STAFF RECOMMENDATION
1126 Shelton Avenue
June 21, 2017

Application: New construction - infill
District: Inglewood Place Neighborhood Conservation Zoning Overlay
Council District: 7
Map and Parcel Numbers: 072030A90000CO
Applicant: David Owen, Orca Building Group
Project Lead: Sean Alexander, sean.alexander@nashville.gov

Description of Project: The proposal is to build three detached single family houses. Each of the buildings would be two-stories tall and have an attached garage.

Recommendation Summary: Staff recommends disapproval of the project at 1126 Shelton Avenue, finding that the proposal does not meet sections III.A (Height), III.B (Scale), III.D (Materials), and III.G (Proportion and Rhythm of Openings) of the design guidelines for the Inglewood Place Neighborhood Conservation Zoning Overlay.

FRONT ELEVATION
SCALE: 1/4" = 1'-0"

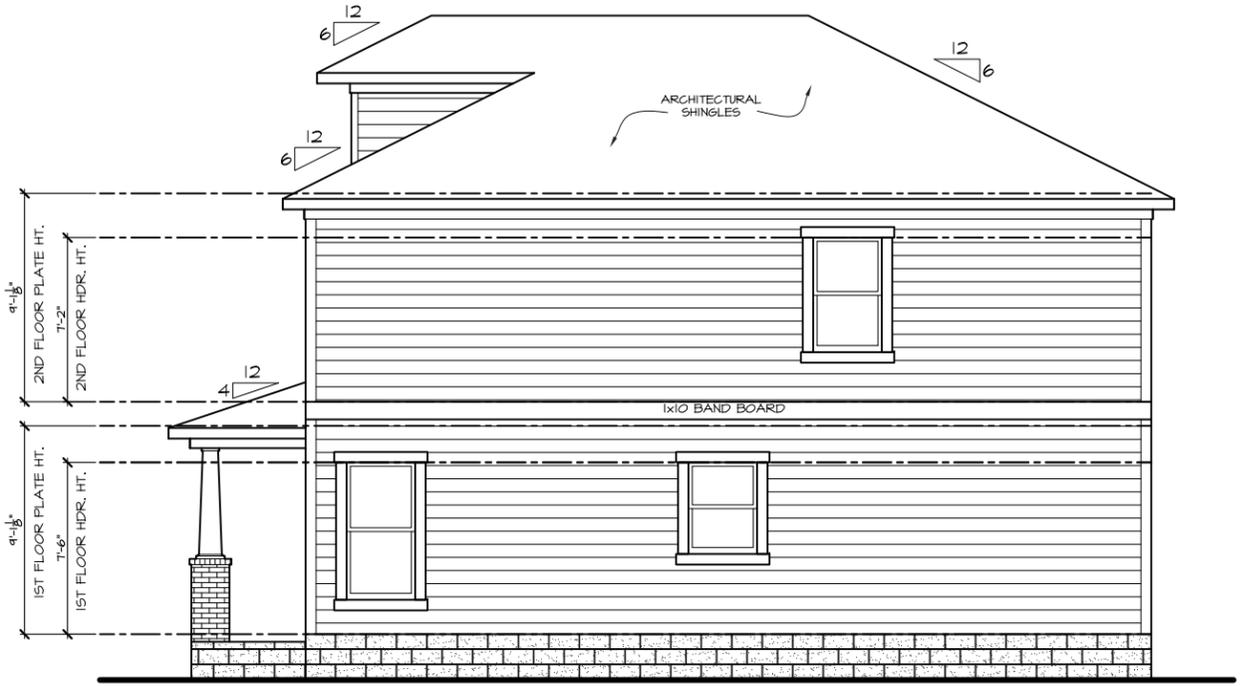
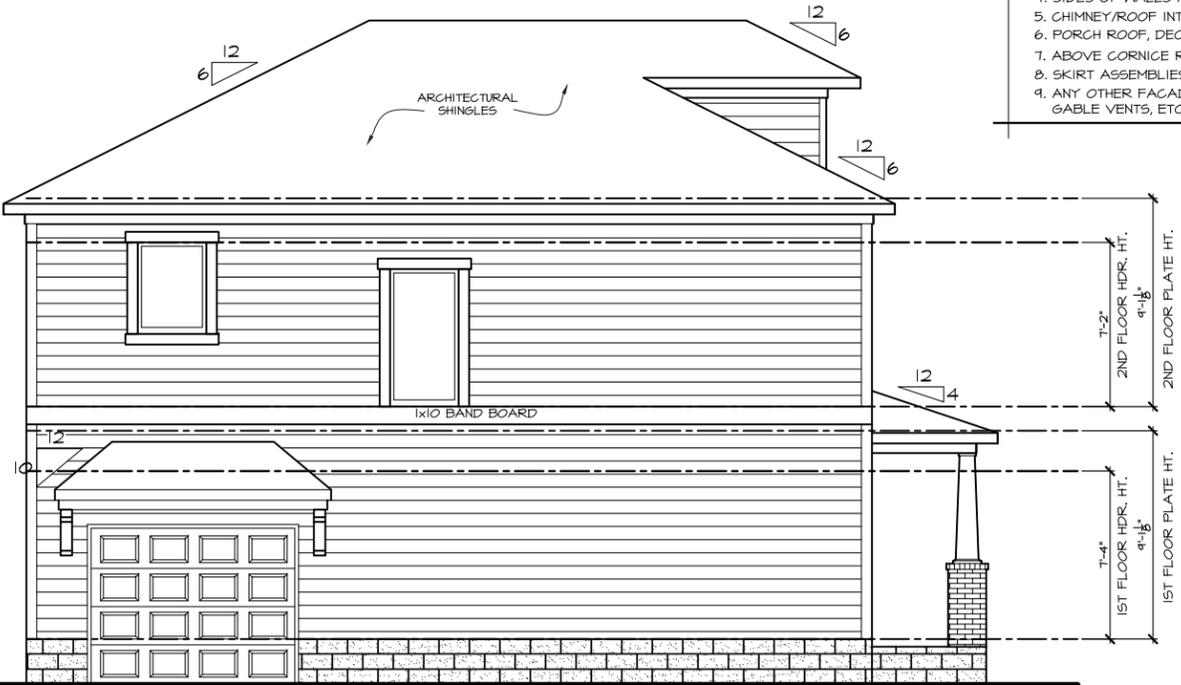
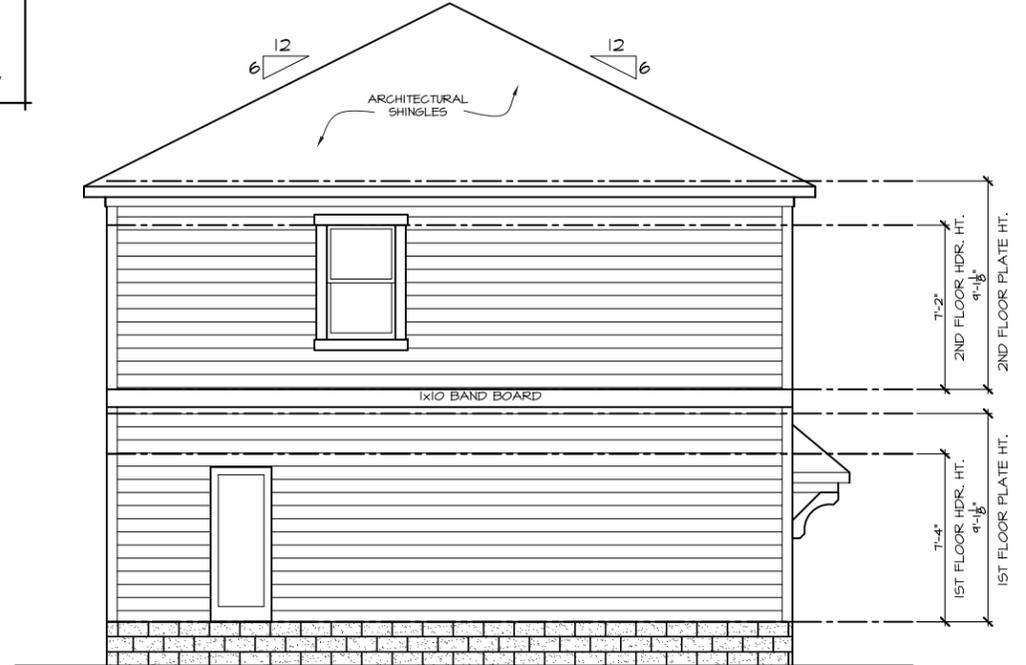
Height & Scale: The house facing Shelton Avenue, Unit 1, is proposed to be two stories tall, twenty-eight feet, six inches (28'-6") from grade to the peak. The two remaining buildings will be behind it and facing Windsor Avenue. Unit 2 and Unit 3 will be two and one-half stories tall, with a peak height of twenty-nine feet (29') above grade. The historic context consists of only one or one and one-half story houses, the tallest being only twenty-six feet (26') tall. Staff finds that the heights and two-story forms of the proposed infill would not meet Sections III.A and III.B of the Inglewood Place design guidelines.

The Unit 1 structure will have a primary mass that spans thirty-three feet (33') in width and depth. An attached garage on the left side expands the width to forty-nine feet (49'). Historic houses in the area typically range between thirty feet (30') and thirty-four feet (34') wide, on lots that are typically fifty feet (50') wide. There are two wider houses on larger lots nearby. At sixty-seven feet (67') wide the lot at 1126 Shelton is roughly a third wider than the typical lot, therefore Staff finds that the width of the house may be appropriate for a one-story form.

Staff finds that the widths are compatible with historic buildings, however the height and number of stories is not appropriate. Overall, the scale of the project does not meet Sections III.A and III.B of the Inglewood Place design guidelines.

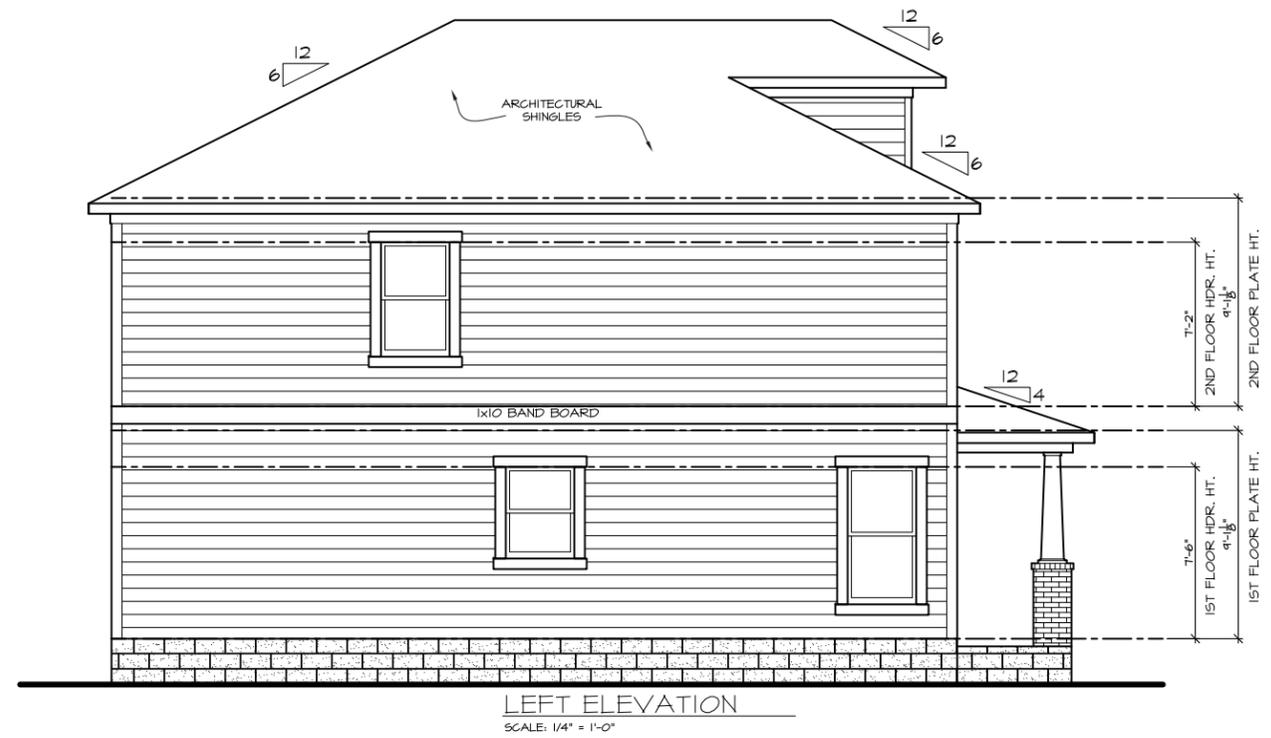
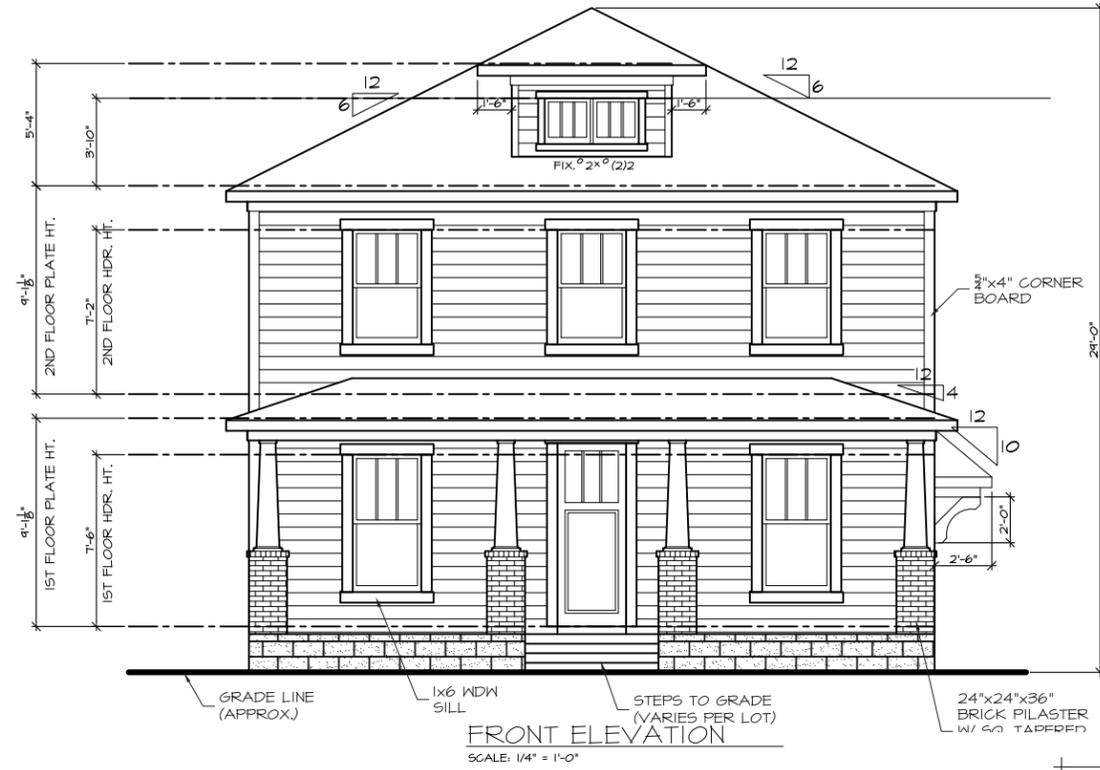
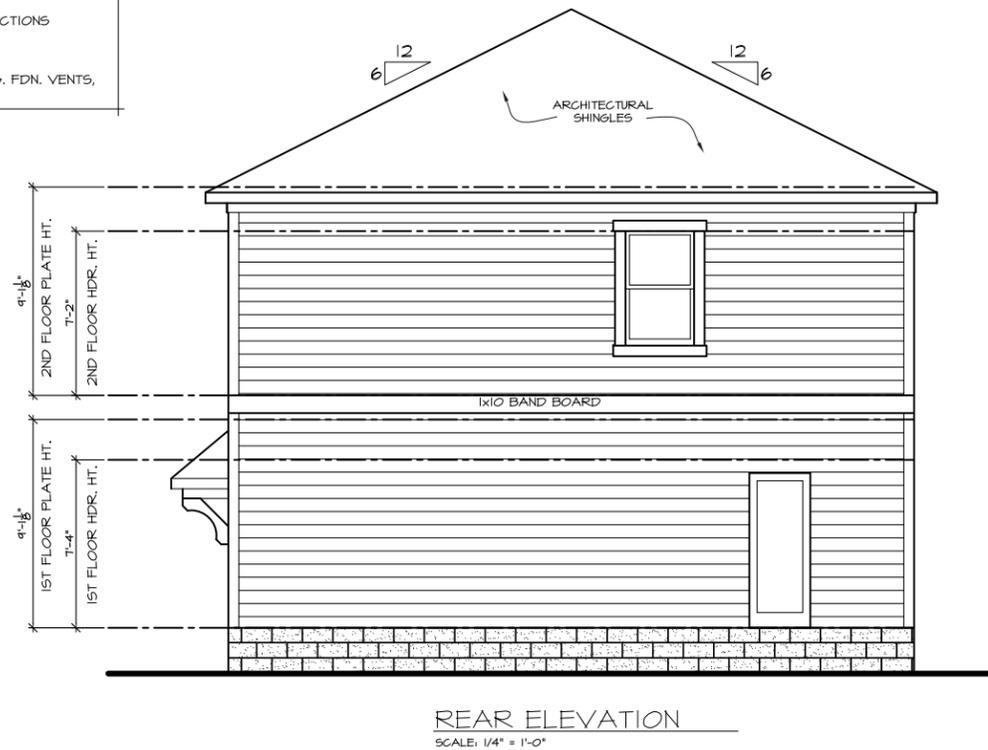
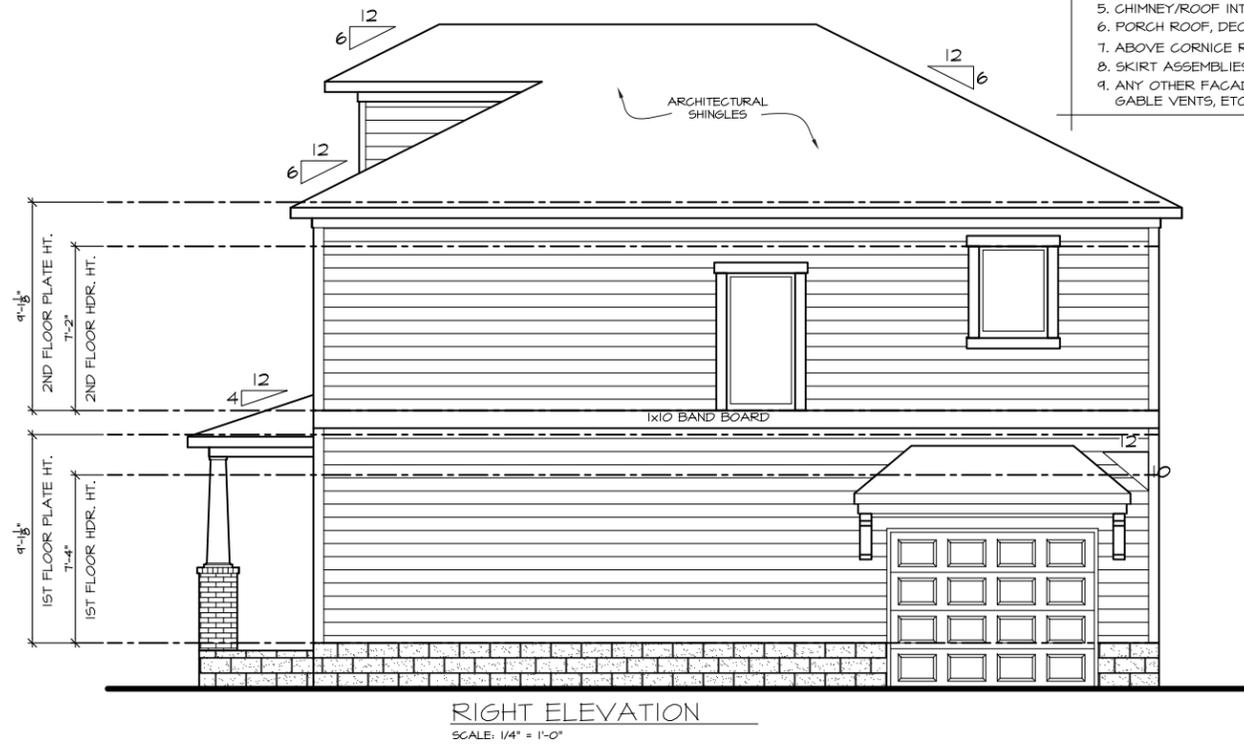
Units 2 and 3 would have thirty foot (30') wide front facades and would be forty-two feet (42') deep. Staff finds that these proportions would be appropriate for buildings with a one-story form.

Units 2 and 3 face Windsor Avenue, and each would have a five foot (5’) deep full-width covered porch. Again, front porches are at least six feet (6’) deep on historic buildings. The plans also show walkways leading from the porches to a new sidewalk on Windsor Avenue.
